DEPARTMENT OF COMMUNITY DEVELOPMENT SERVICES

DATE: April 9, 2009

SUBJECT: LB DRB-2009-01: A request by Nabor House Fraternity for design approval for a fraternity house at 1002 S. Lincoln Avenue and 805 W. Iowa Street in the R7 University Residential and R3 Single and Two-Family Residential zoning districts.

PROPOSED EAST ELEVATION
NABOR HOUSE FRATERNITY, URBANA, IL.
 SCALE: 1/8" = 1'-0" 0 1 2 4 8
 02-12-08 JOB #0532

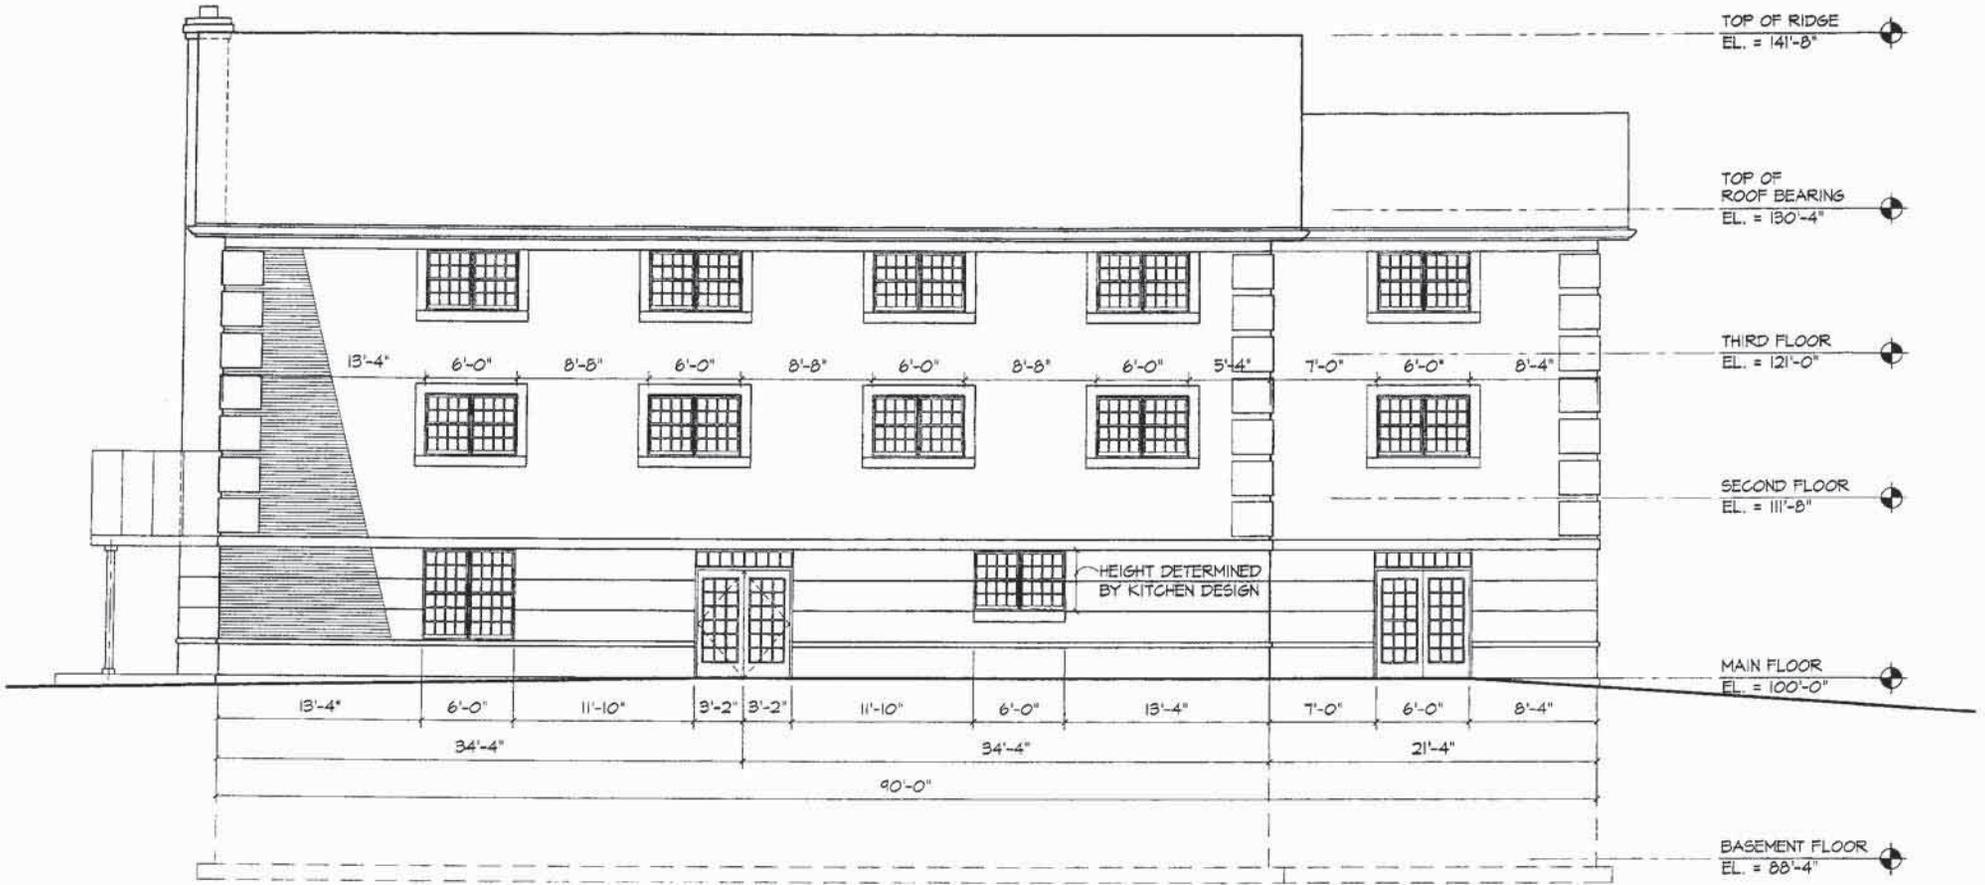
The proposed house is on a corner lot. The façade zone includes both the north and the west elevations. All elevations contain window openings and have large planes broken up through the use of bays and bands. The central bay on both the Iowa Street and Lincoln Avenue facades are a focal point, with Palladian windows and doors. City staff recommends that the DesRB find that the proposal meets the design guidelines for Façade Zone.

The primary entrance on Iowa Street is clearly defined, with a Palladian door and a small entry porch. Although the Lincoln Avenue entrance is not the primary entrance, it is still a prominent entrance with a transom and sidelights on either side of the door and a rising sun symbol above the door on the porch roof. City staff recommends that the DesRB find that the proposal meets the design guidelines for Building Orientation.

The proposed building would have a gable roof, which is the predominant roof form in the Corridor. The plans call for the roof pitch to be 5.5:12, slightly less than the encouraged roof pitch of 6:12, but appropriate to the architectural style. The north elevation includes dormers to help soften the mass of the roof, and the east elevation makes use of a smaller gable as well. City staff recommends that the DesRB find that the proposal meets the design guidelines for Roof Lines.

The pattern of openings on the primary two facades is symmetrical and balanced. The windows all have a window surround appropriate to the architectural style. The windows on the first story are taller than those on the second and third stories, as is appropriate to demarcate the prominence of the public rooms generally found at ground level. The windows are simulated divided lights. The windows are vertically oriented. City staff recommends that although the windows are not true divided lights, sufficient encouraged guidelines are included in the proposal to satisfy the design guidelines for Window & Door Openings.

**PROPOSED SOUTH ELEVATION
NABOR HOUSE FRATERNITY, URBANA, IL.**

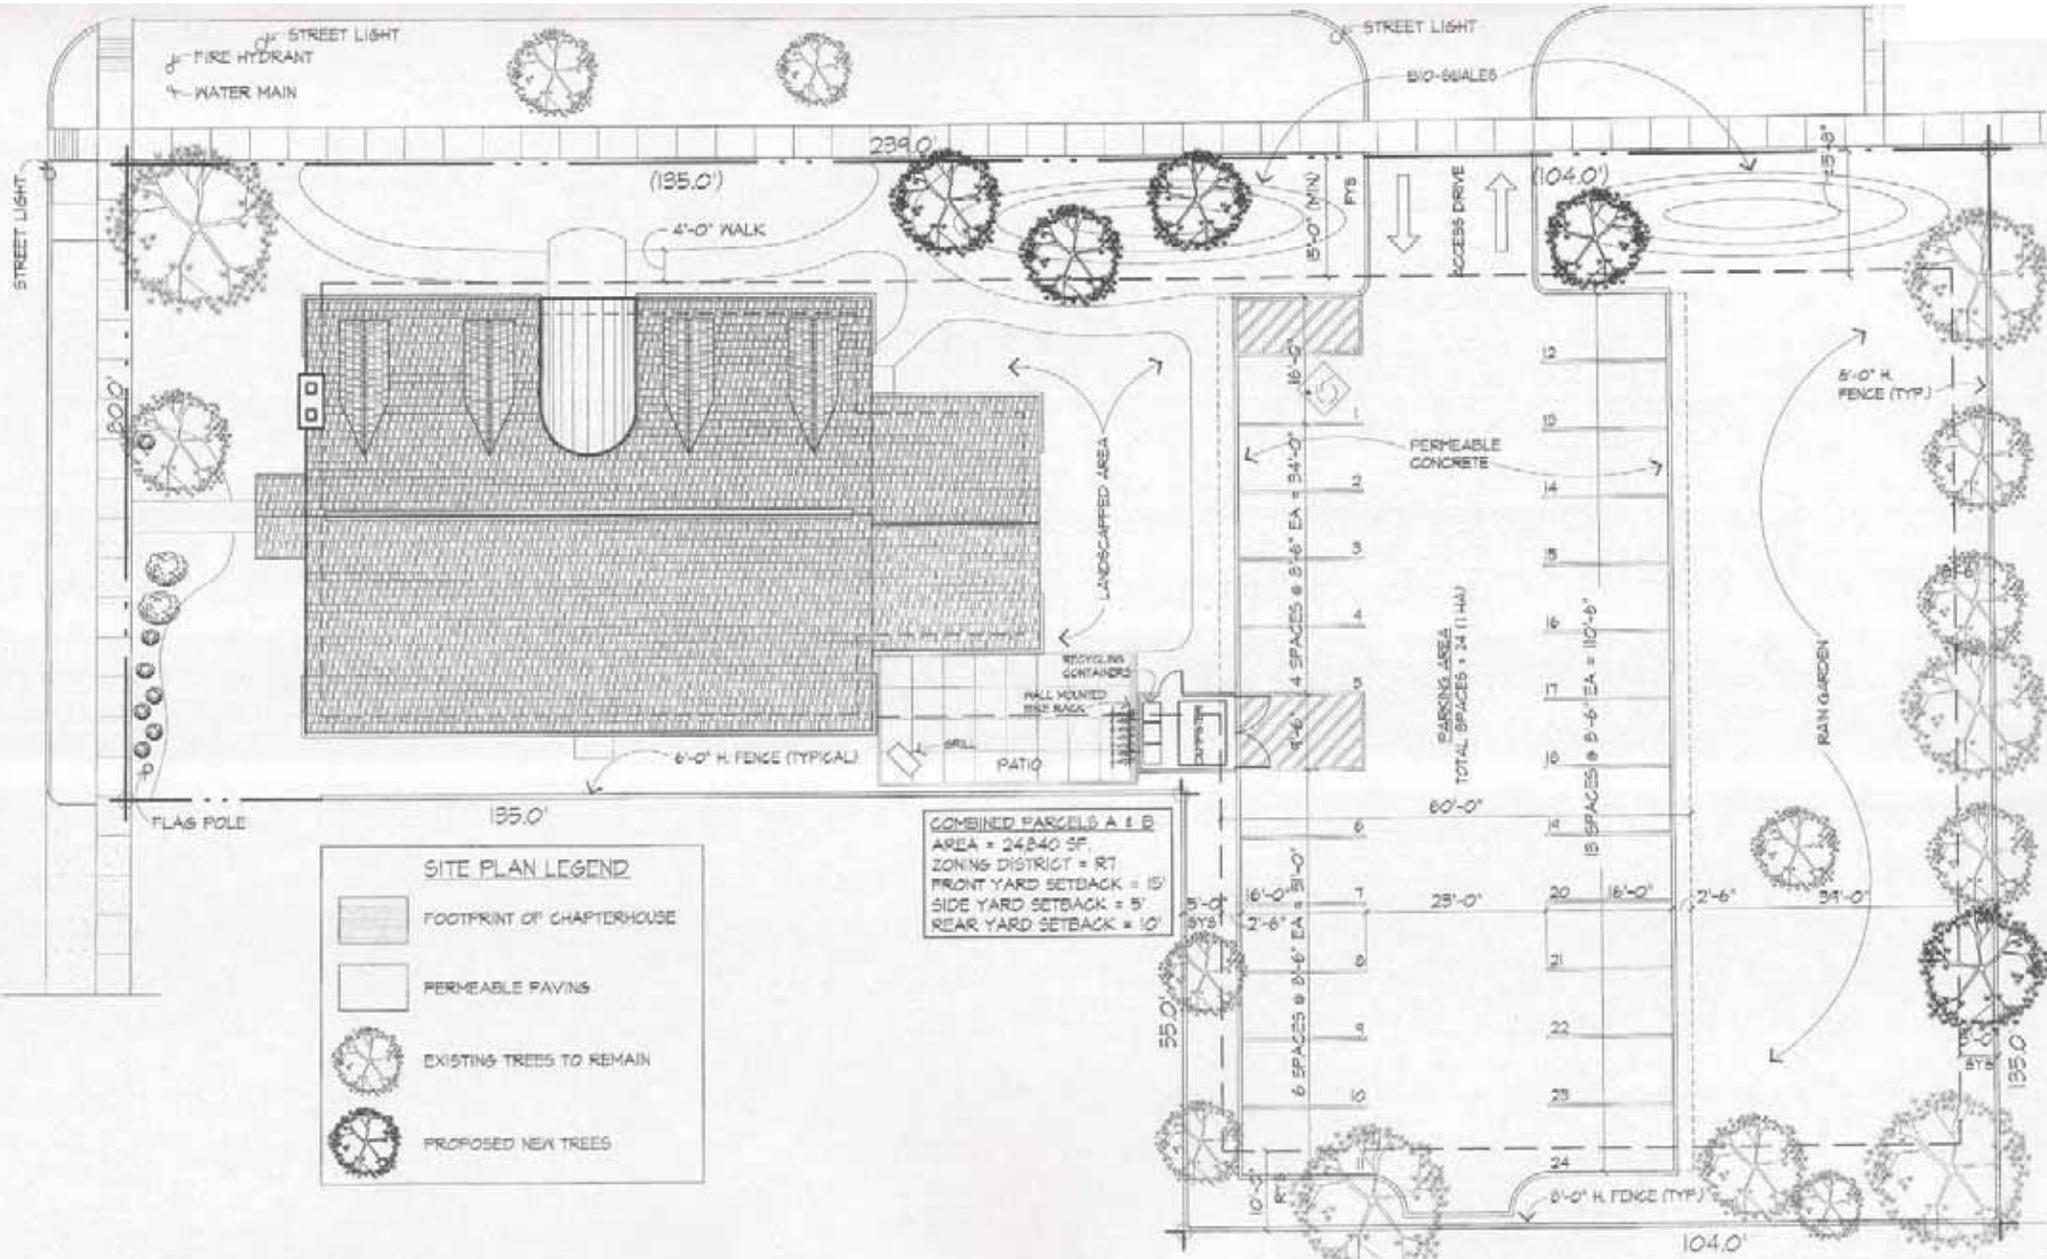
Most of the existing trees on the subject lots would remain, with the exception of seven trees on the west half of the lot on Iowa Street and one street tree on Iowa Street. (See the existing and proposed site plans in Exhibit B.) The proposal calls for the installation of five new trees, in addition to a rain garden to act as a buffer for the single family homes to the east. City staff recommends that the DesRB find that the proposal meets the design guidelines for Landscaping.

The proposal includes a 24-space parking lot to the rear of the fraternity house. The parking lot will be screened from the single family houses to the east by a fence, landscaping and a rain garden. The parking lot will be partially screened from Iowa Street by several new trees. The parking lot will be surfaced with a permeable paving material to prevent runoff. City staff recommends that the DesRB find that the proposal meets the design guidelines for Parking.
